Conceptual Review Agenda

Schedule for 04/15/13 to 04/15/13

Re: 302 Meldrum - Microbrewery

Description of project: This is a request to utilize an existing structure as a microbrewery located at 302 North Meldrum Street (Parcel # 97111-37-001). Changes to the site include the addition of a deck and ADA ramp, bike parking and a silo. The site is located in the Civic Center subdistrict of the Downtown (D) Zone District and also within the Transit Oriented Development Overlay (TOD). Microbreweries are subject to Planning & Zoning Board (Type 2) review in the Civic Center/Downtown Zone District.

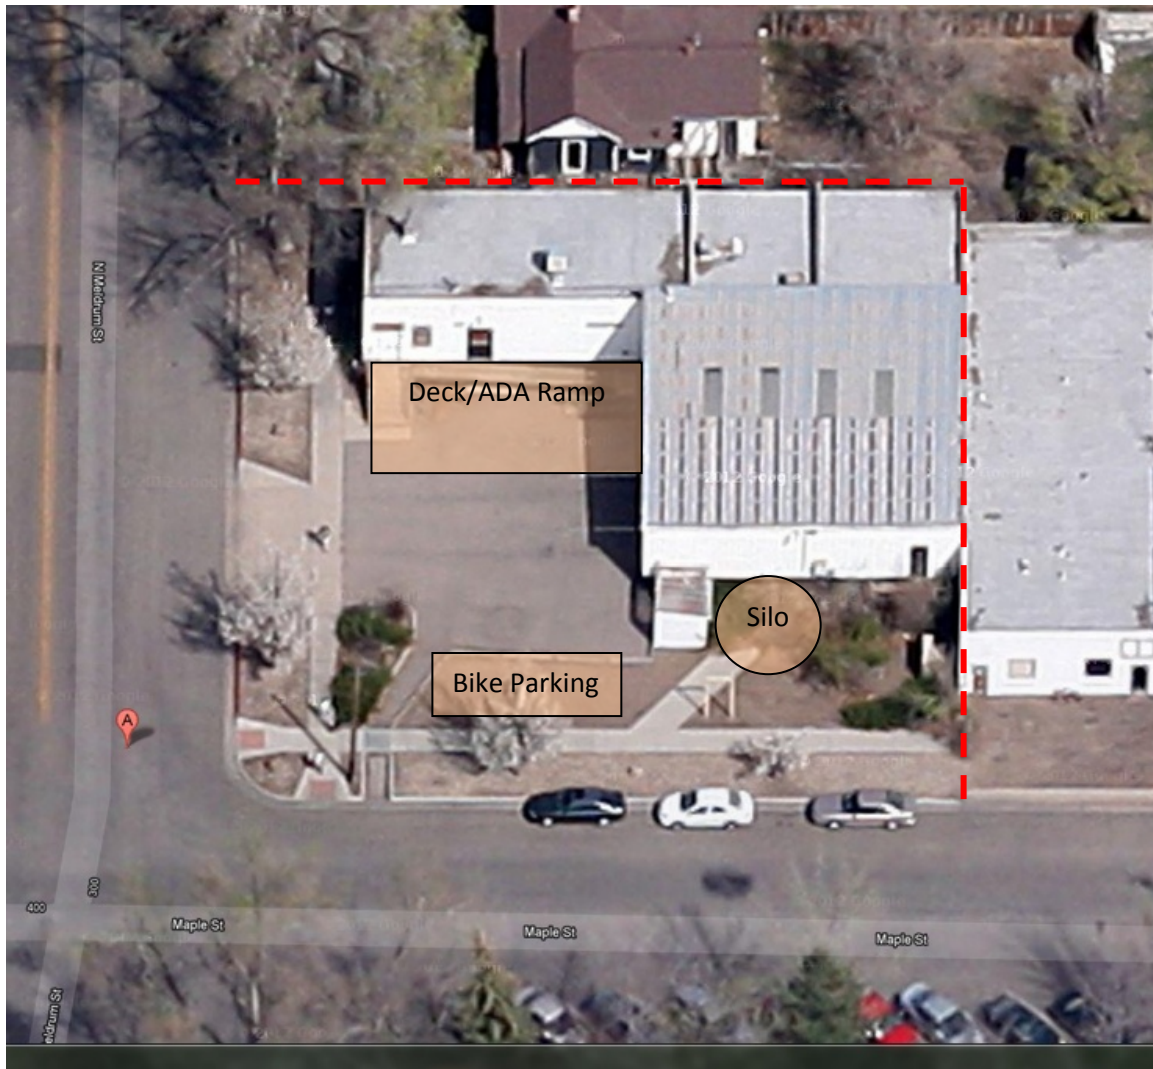
1. Floodplain Comments:
A small portion of this property, including a part of the existing commercial building, is located in a City

regulatory 100-year flood floodway and flood fringe in the Old Town Basin, and must satisfy the standards of Chapter 10 of City Code. That Code stipulates that if any part of a building is in the floodplain, the entire building is considered to be in the floodplain. A City Flood Risk Map is attached.

Site Plan
1" = 40'-0"

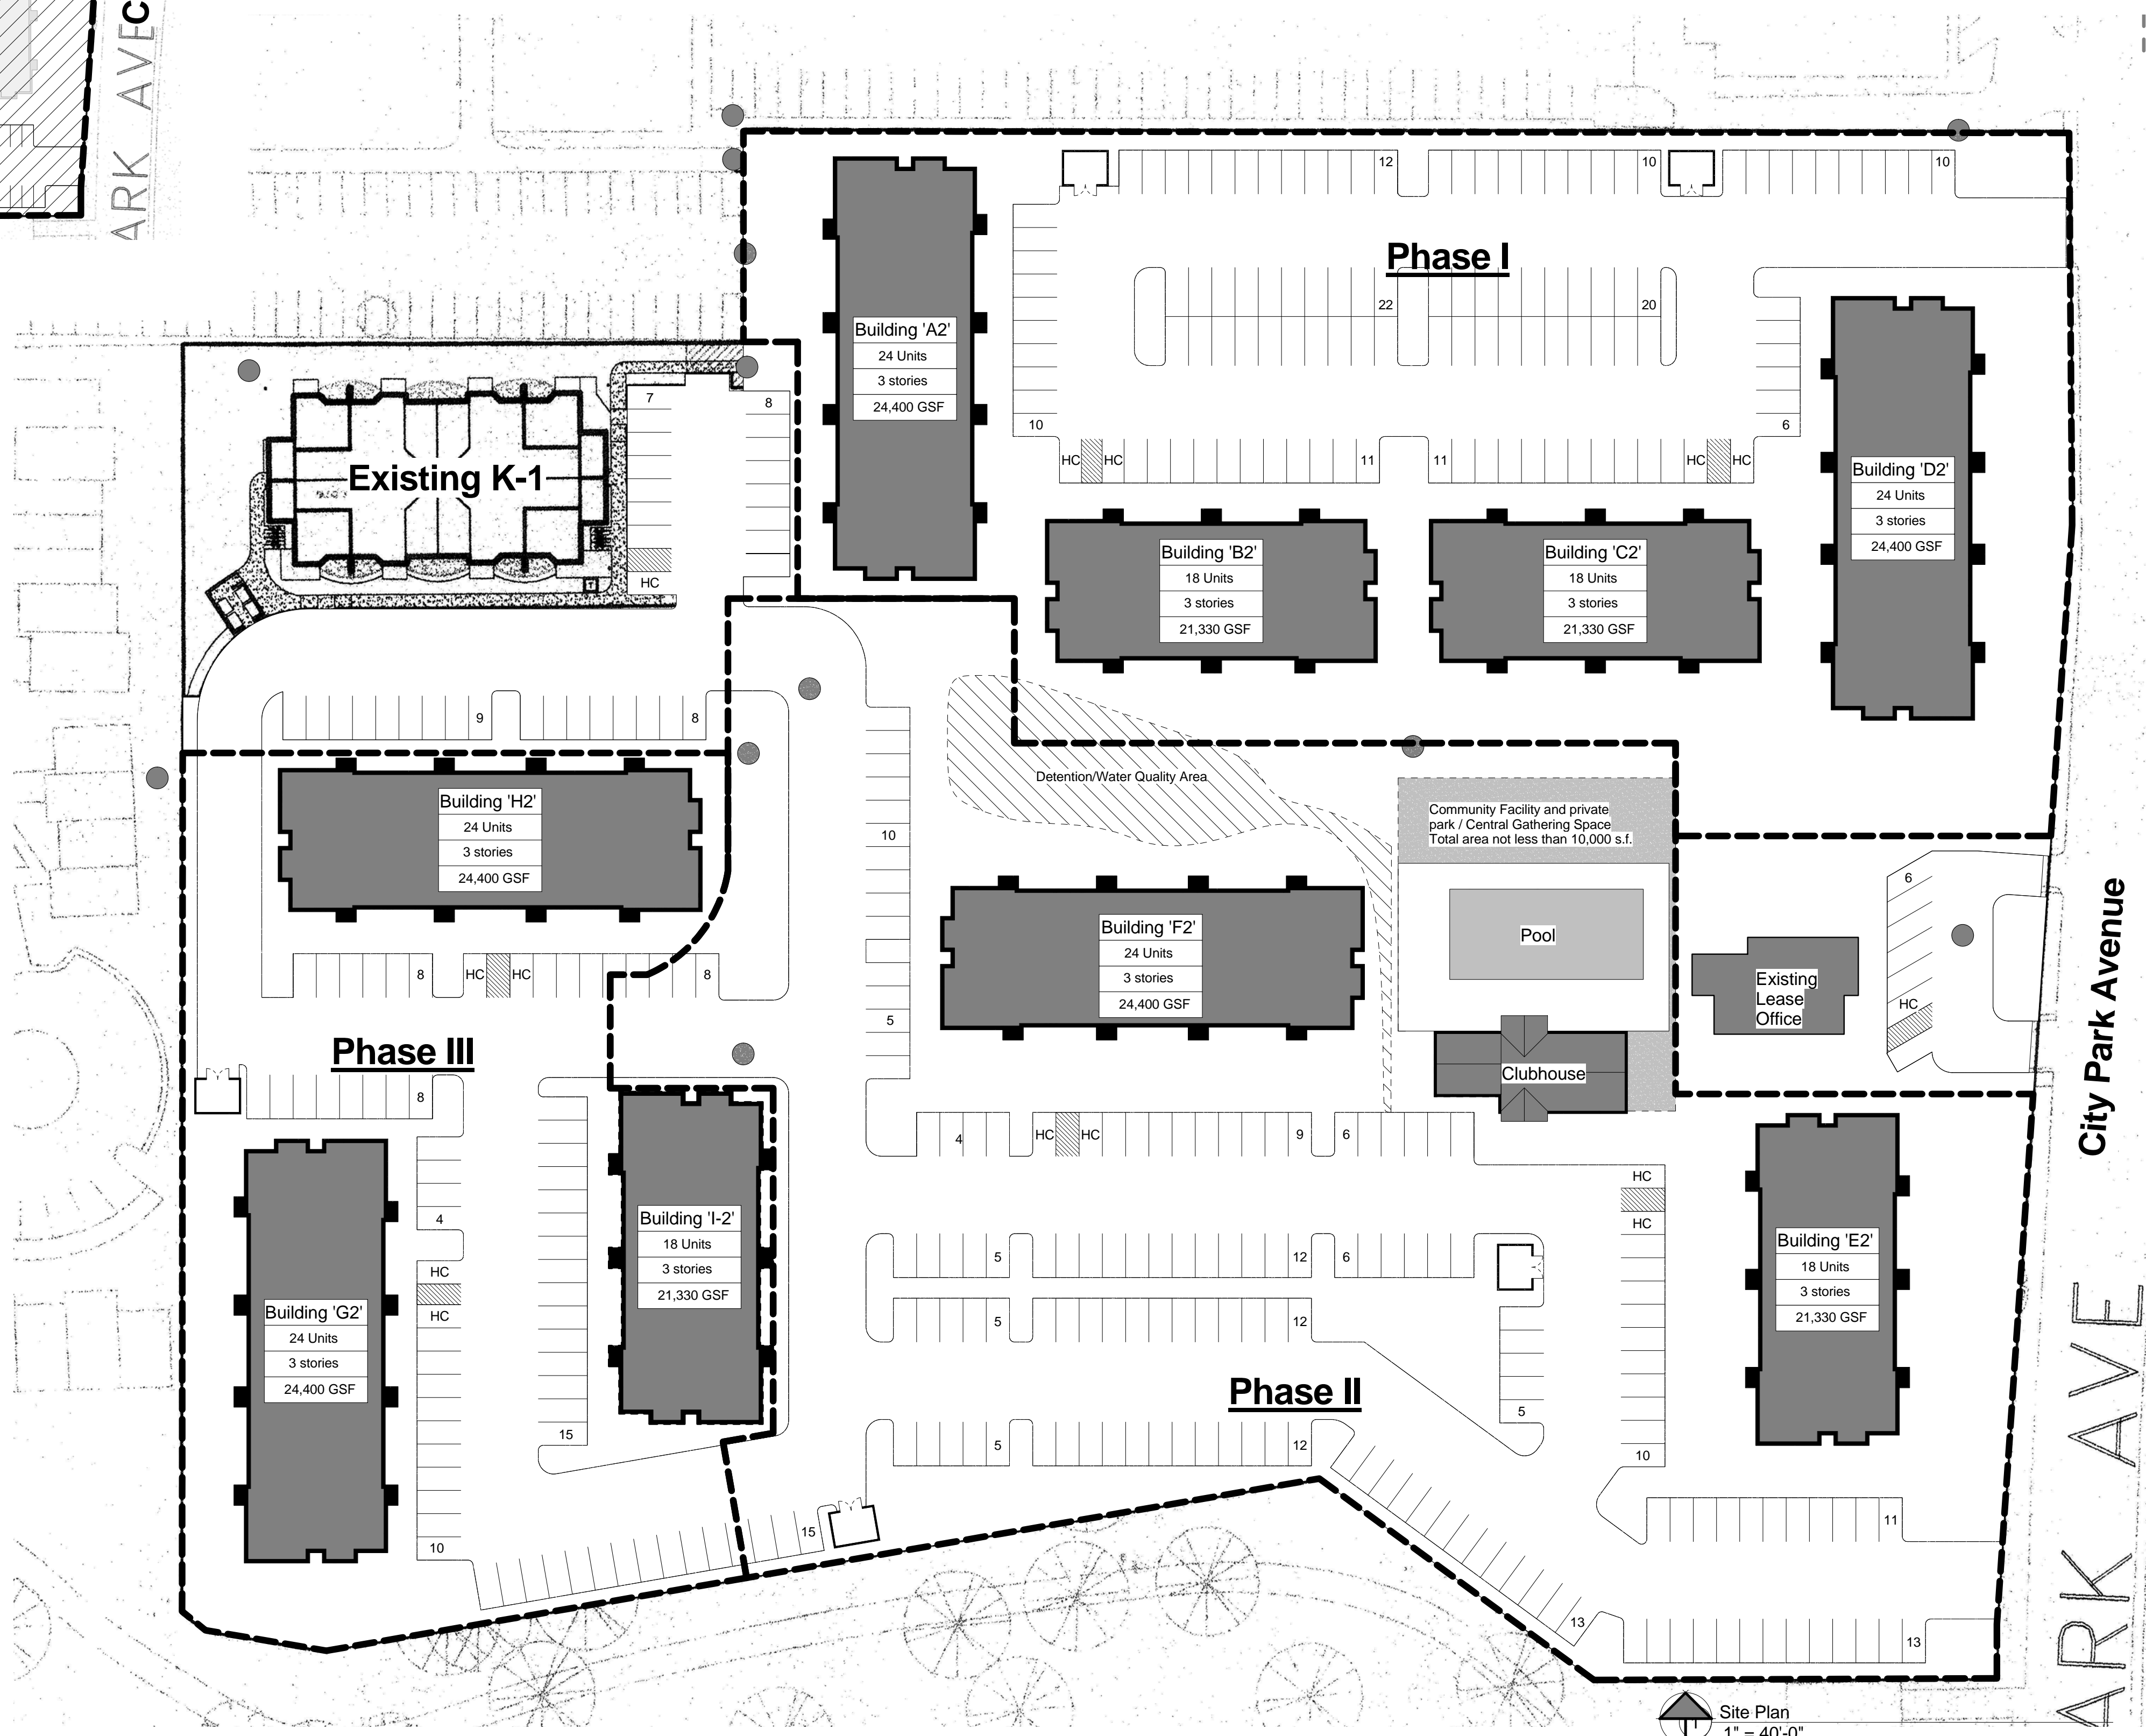
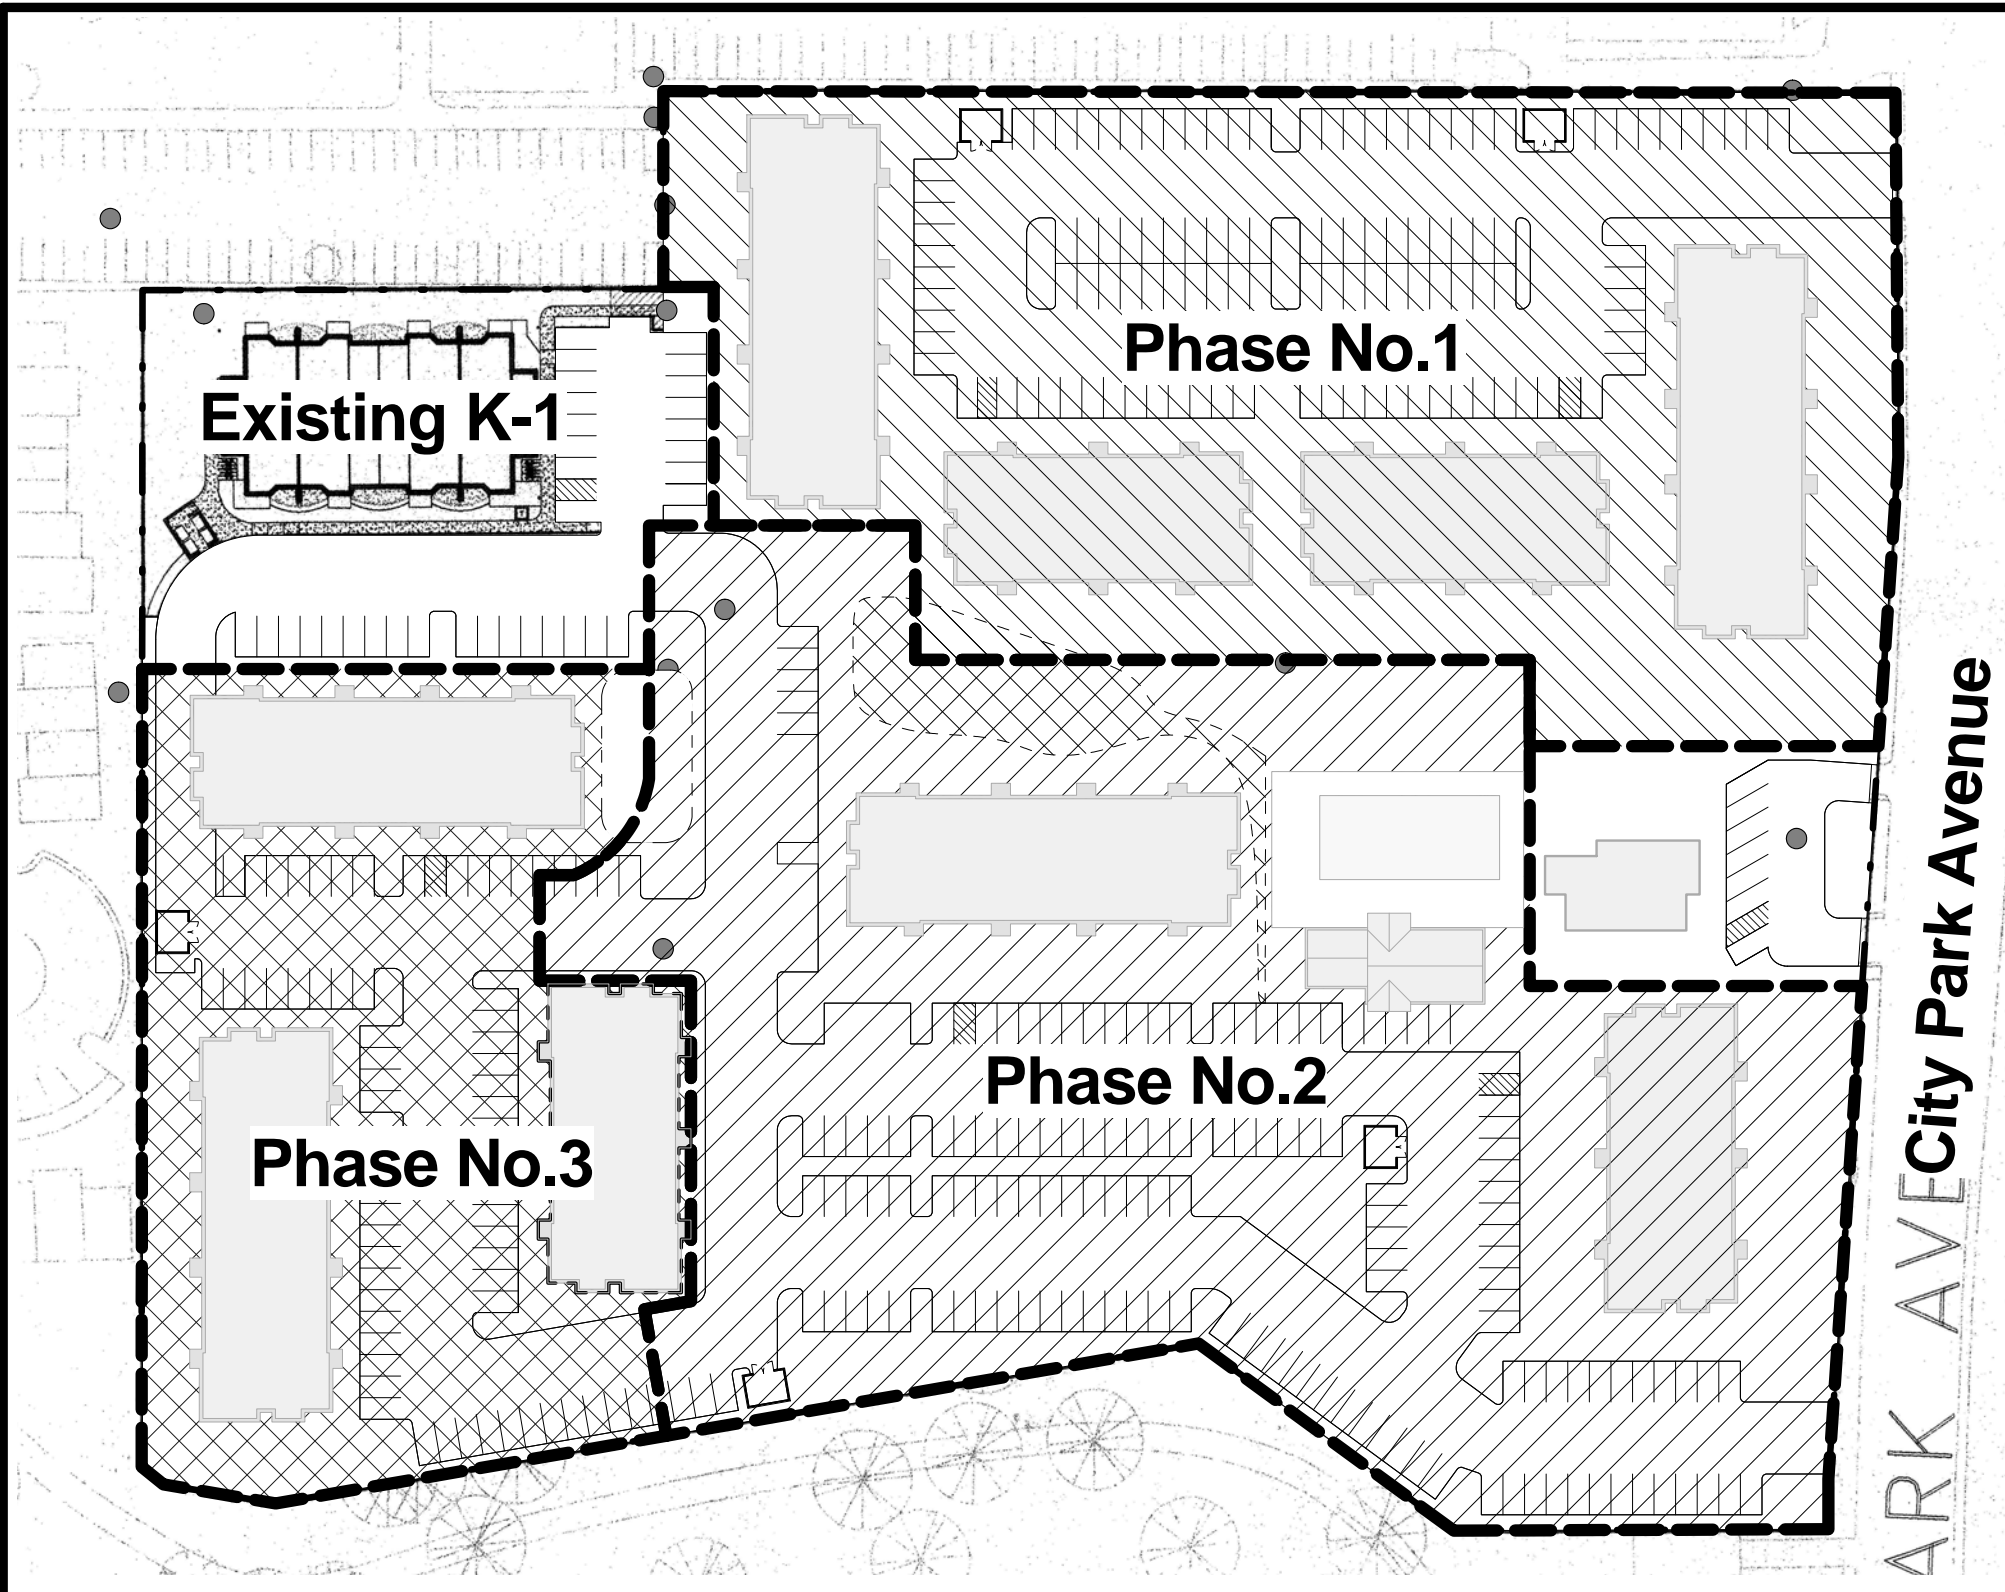
4. Building K is identified as the only residential building that will not be demolished. If there are plans to remodel Building K as part of this project, that work will have to comply with Chapter 10 standards. Remodeling of a residential structure is allowed in a City high risk flood fringe as long as the cost of the improvements (over a 12-month period) does not equal or exceed 50 percent of the market value of the structure. If the cost of improvements does exceed 50 percent of the market value of the structure, the building is considered to be Substantially Improved, and the lowest floor of the structure as well as all duct work, heating, ventilation and air-conditioning systems, electrical, hot water heaters, etc. must be elevated a minimum of six-inches above the Base Flood Elevation (BFE) for the property. That elevation is known as the Regulatory Flood Protection Elevation (RFPE). For a residential remodel, $RFPE = BFE + 6"$. A new basement may not be constructed below the RFPE in connection with remodeling of a residential structure. A FEMA Elevation Certificate will have to be completed before a Certificate of Occupancy (C.O.) can be issued for the remodeled building.

5. A part of the northwestern corner of the property is located in the 100-year floodway. Nonstructural development (parking lots, driveways, sidewalks, vegetation, etc.) can be built within the floodway as long it can be proven that the work will not cause a change in the Base Flood Elevation (BFE), or a change to the boundaries of the floodway or flood fringe. This is called a No-Rise Certification and it

6. Since the site is not within the T.O.D., the required minimum number of parking spaces is required. Based on the application, a Modification of Standard will be needed to Section 3.2.2(K). The criteria by which the Board can grant a Modification is in Section 2.8.2(H).
